SMALL BREAK LOCA MODEL RESOLUTION

NRC CONCERNS AND RESOLUTION

CCFL ACROSS CORE

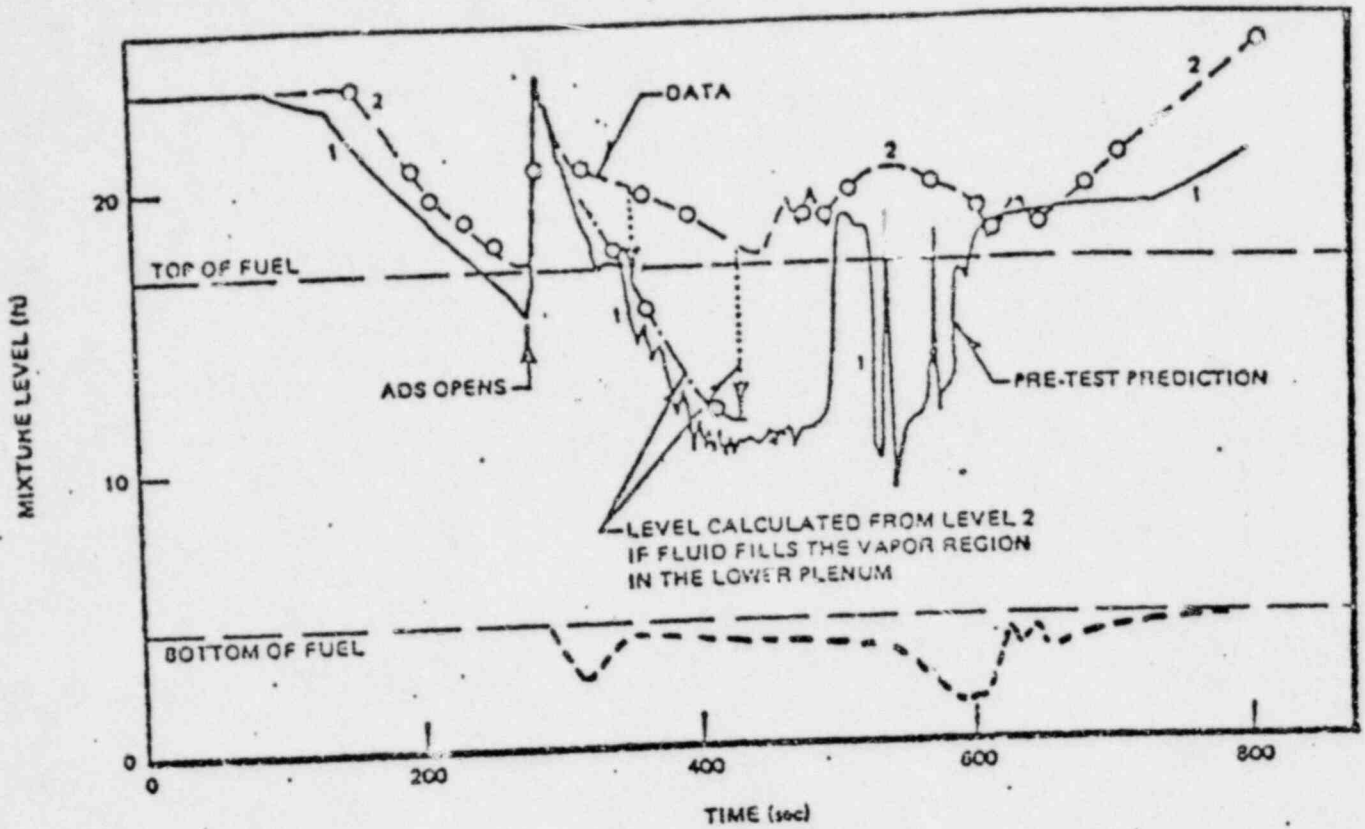
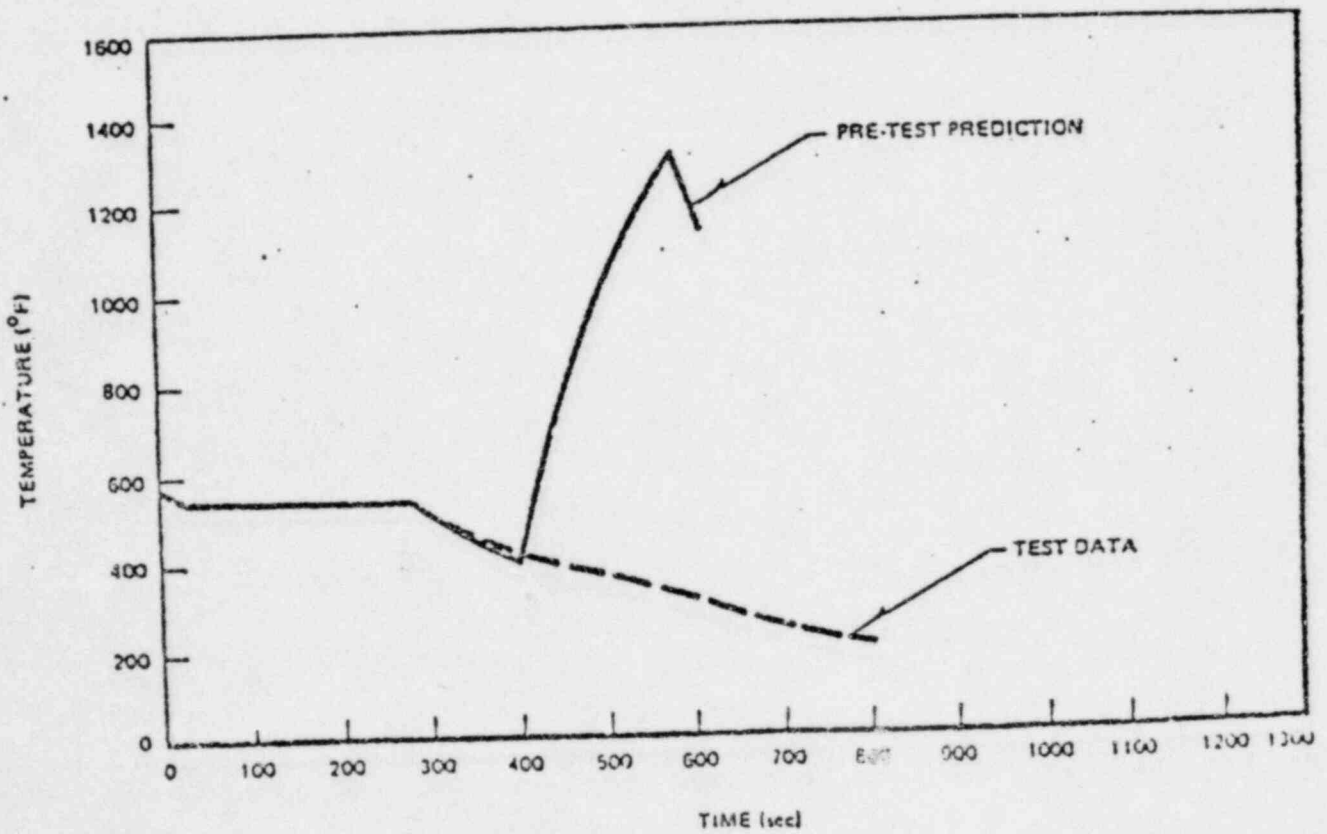
- NRC CONCERN.  
CCFL INFLUENCE ON SMALL BREAKS DURING  
CORE UNCOVERY IS NOT ACCOUNTED FOR IN SAFE.
- RESPONSE:
  - SAFE/REFLOOD COMBINATION USED.
  - CCFL AT TOP OF CORE INCLUDED IN REFLOOD.
  - CCFL AT BOTTOM CONSERVATIVELY NEGLECTED.
    - ANALYTICAL STUDIES (REF.1).
    - TLTA COMPARISONS (REF.2).
- RESOLUTION  
CCFL IS CONSERVATIVELY ACCOUNTED FOR IN  
SMALL BREAK METHODS

TREATMENT IS ADEQUATE

Two-Phase Mixture Level — Inside the Shroud

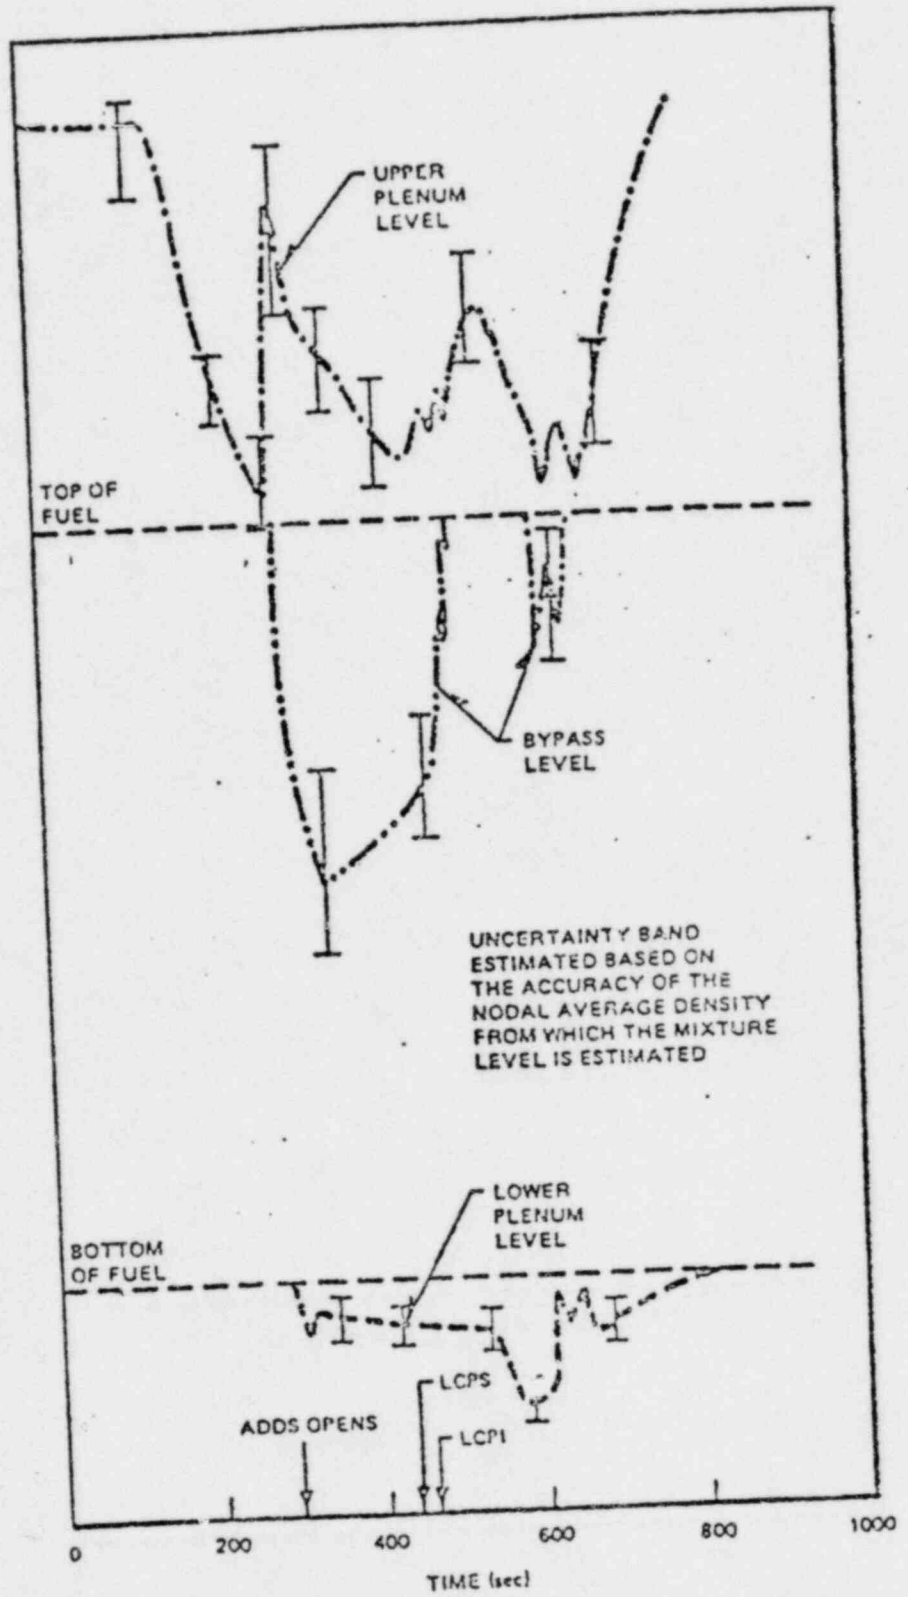
- NRC CONCERN.  
SAFE DOES NOT DISTINGUISH THE BYPASS INVENTORY FROM THE CORE INVENTORY.

- RESPONSE:
  - SAFE/REFLOOD COMBINATION USED.
  - REFLOOD MODELS BYPASS SEPARATELY.
  - OVERALL COMPARISONS TO TLTA SHOW THAT THE MODELS ARE CONSERVATIVE. (REF. 2)

- RESOLUTION  
BYPASS IS SEPARATELY MODELED IN SMALL BREAK METHOD

TREATMENT IS ADEQUATE

REACTOR SYSTEM

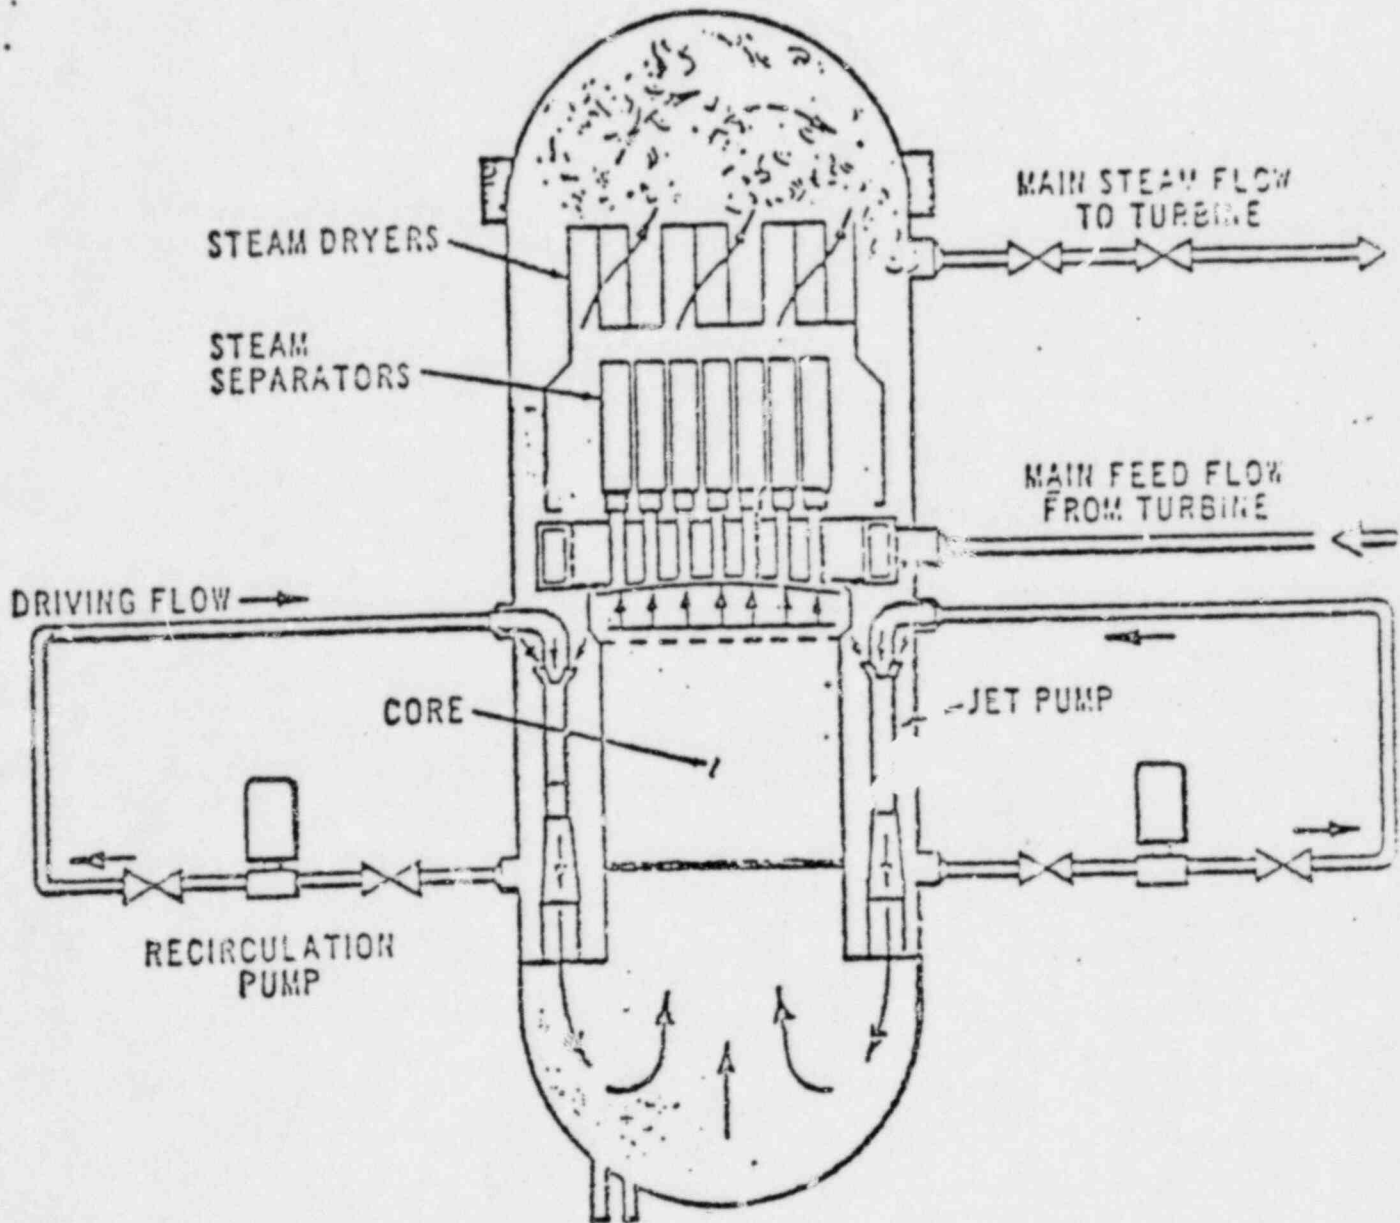
THE GE MODEL INCORPORATES THE RECIRCULATION LINE INVENTORY INTO THE DOWNCOMER. GE SHOULD SHOW HOW THIS MODELING TECHNIQUE INFLUENCES SMALL BREAKS WHEN THE INVENTORY IN ONE OR BOTH OF THE RECIRCULATION LOOPS IS NOT DEPLETED.

- RECIRCULATION LINE INVENTORY IS INCLUDED IN SAFE DOWNCOMER
  - ONLY 2% OF TOTAL SYSTEM VOLUME

- IMPACT OF LUMPING THIS VOLUME
  - $\Delta PCT$  (+20 TO -40°F)

- IMPACT OF LUMPING THIS VOLUME AT BOTTOM OF DOWNCOMER
  - $\Delta PCT$  (+25 TO -40°F)

TREATMENT IS ADEQUATE

# COMPARISON OF SYSTEM PRESSURE DROP

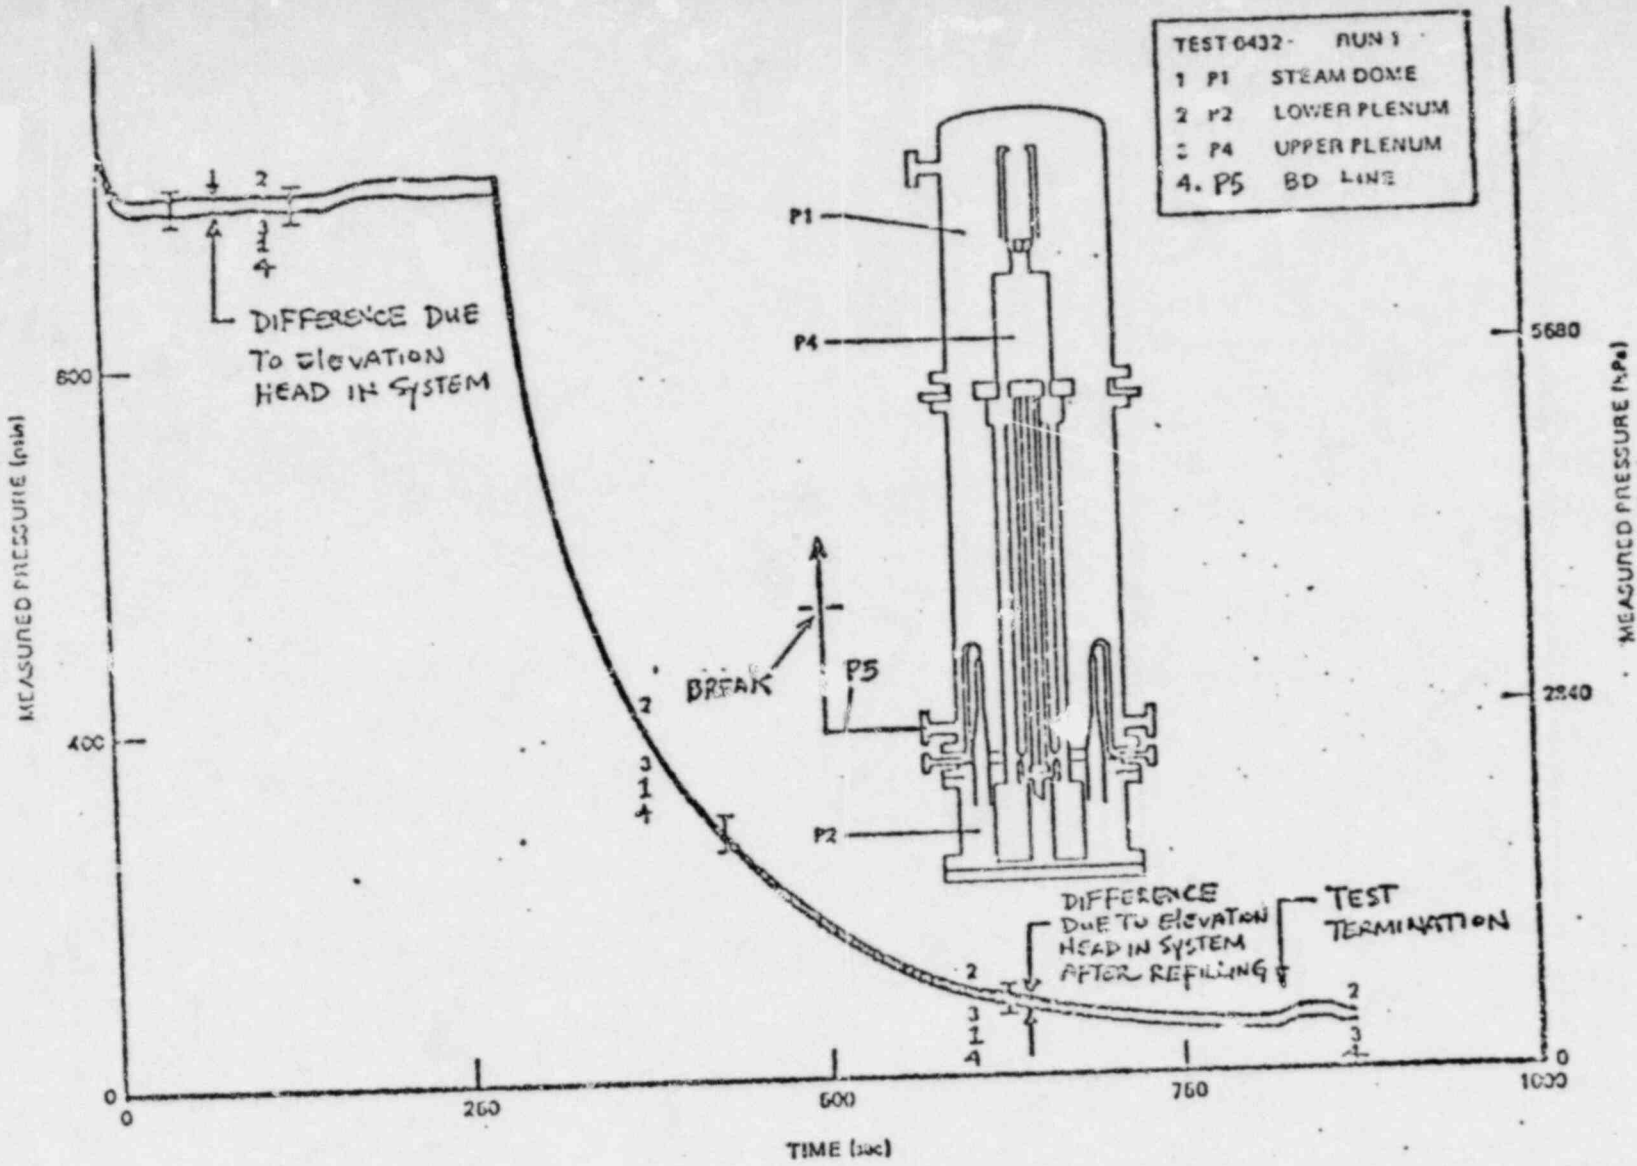
WHAT IS EFFECT OF NEGLECTING PRESSURE VARIATIONS (THERMODYNAMIC) WITHIN REACTOR VESSEL (OTHER THAN STATIC HEADS).

- TRAC ANALYSES OF TLTA
  - SHOW ONLY STATIC HEAD SIGNIFICANT AFTER PUMP COASTDOWN
- TLTA RESULTS SHOW SAME EFFECT
  - BASED ON > 60 PRESSURE DROP MEASUREMENTS
- TLTA DATA FURTHER DEMONSTRATE ADEQUACY OF ASSUMPTION:
  - THROUGHOUT SYSTEM
  - NEAR BREAK
  - DURING SUBCOOLED ECCS INJECTION

TREATMENT IS ADEQUATE

Figure 3.1.1.4-6A. Small Top Break Blowdown Test With And Without Initial Fluid Subcooling

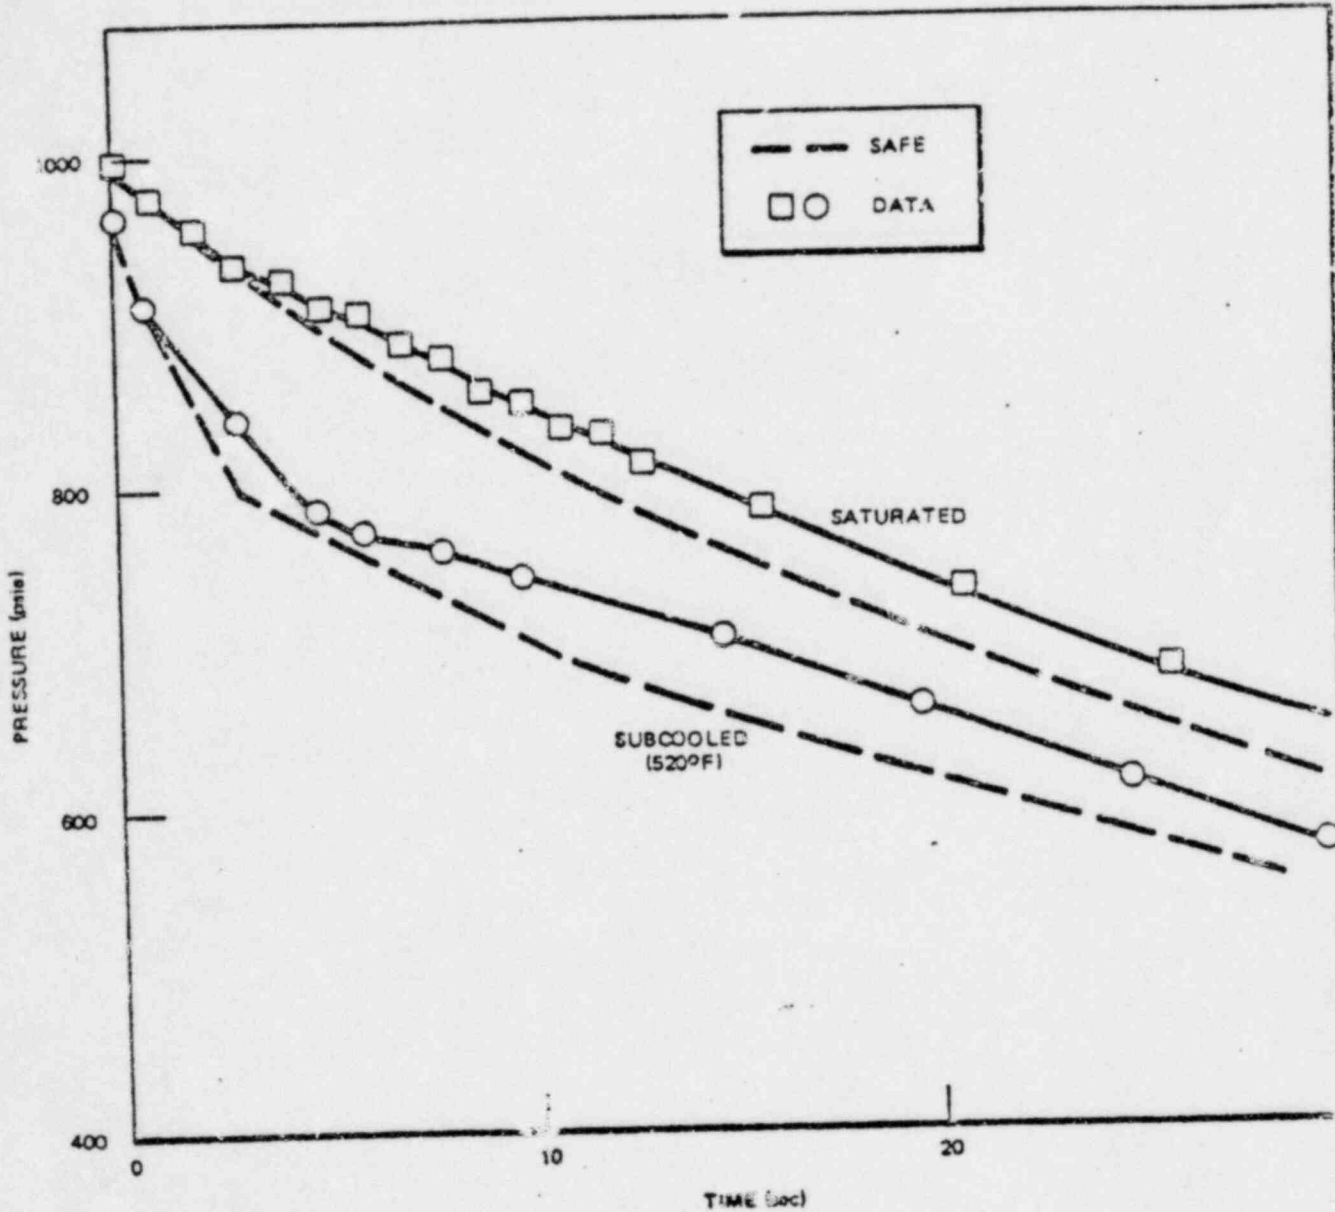
GE SHOULD INVESTIGATE THE INFLUENCE OF THE HOMOGENEOUS-EQUILIBRIUM ASSUMPTION USED IN THEIR LOCA CODES AND THEIR INFLUENCE ON SYSTEM DEPRESSURIZATION RATES.

- NON-HOMOGENEITY INCLUDED IN MODELS
  - BUBBLE RISE/VOID DISTRIBUTION
- MODEL ALLOWS FOR NON-EQUILLIBRIUM
  - SENSITIVITY STUDIES SHOW NO EFFECT
- BWR HAS SLOW BLOWDOWN TRANSIENT
  - RESPONSE GOVERNED BY THERMODYNAMIC EQUILIBRIUM
- TLTA SHOWS NO LOCAL DEPRESSURIZATION DUE TO SUBCOOLED INJECTION
- OTHER BLOWDOWN EXPERIMENTS WITH LOCAL SUBCOOLING ADEQUATELY PREDICTED

PRESENT ASSUMPTIONS ADEQUATE

Figure 7. Comparison of Differential Levels, TLTA Small Break Test I

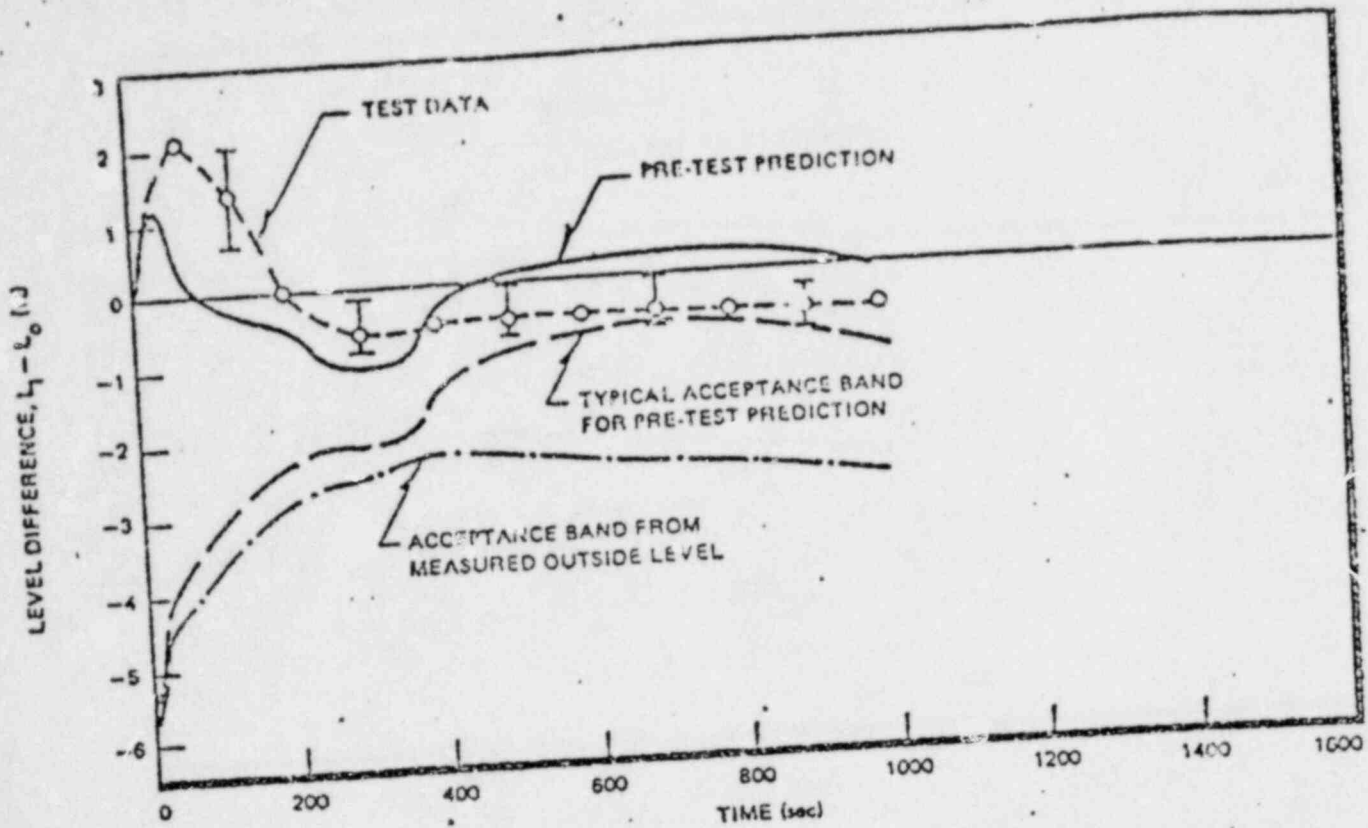
INTEGRAL EXPERIMENTAL VERIFICATION SHOULD BE CONDUCTED TO ASSESS THE OVERALL ADEQUACY OF THE COMPUTER CODES USED IN MODELING A SMALL BREAK LOCA.

- PRE TEST PREDICTIONS VS. INTEGRAL TLTA COMPARISONS
- POST TEST EVALUATIONS OF TLTA
- PREDICTIONS OF OTHER BLOWDOWN TESTS

OVERALL ADEQUACY CONFIRMED
